ERRATA

Item: 5 - Errata

Subject: Update of Monitoring in Freshwater Creek and Elk River

Figure 1. Average residual pool depth conditions in Elk River

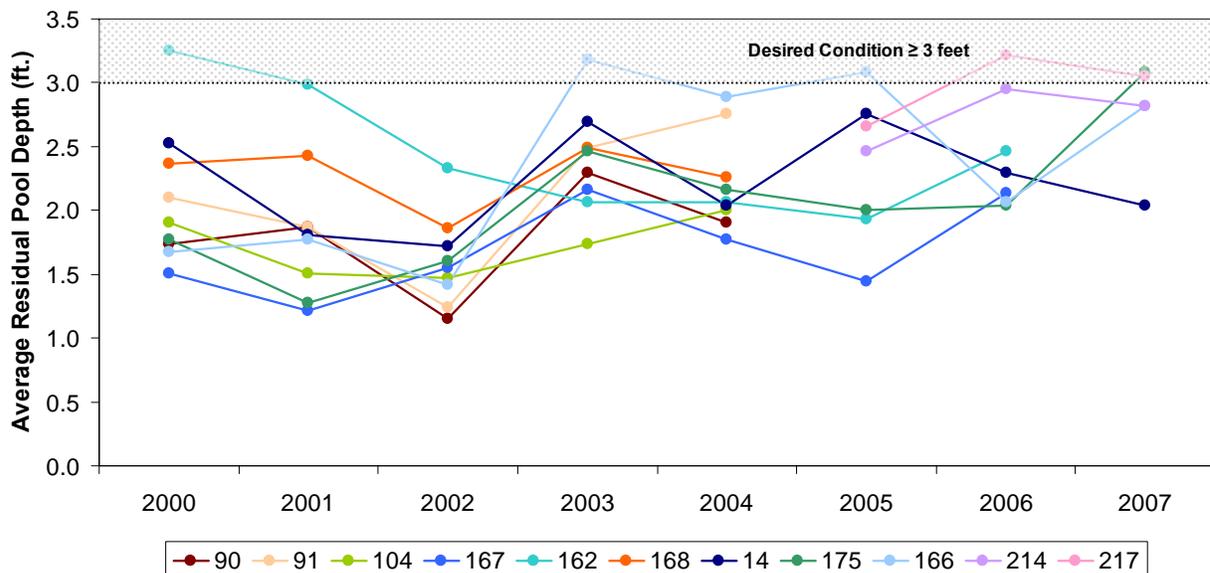
This errata corrects an error in the Executive Officer's Summary Report (EOSR) for this item dated September 2, 2008. The correction is to pool depth data presented in Figure 5 of the Executive Officer's Summary Report; the data corresponding to 2005-2006 was measured in meters and erroneously reported as feet. Figure 1, below, provides the corrected data and replaces Figure 5 (page 6) of the EOSR. Additionally, the 2007 data were recently submitted by PALCO and are included in Figure 1, below.

Over the period of record, there is not an observable trend in the data. There were fluctuations between 2002-2004 at most stations. As of 2007, of the five stations measured, four either met or nearly met the target. The Mainstem station did not meet the target.
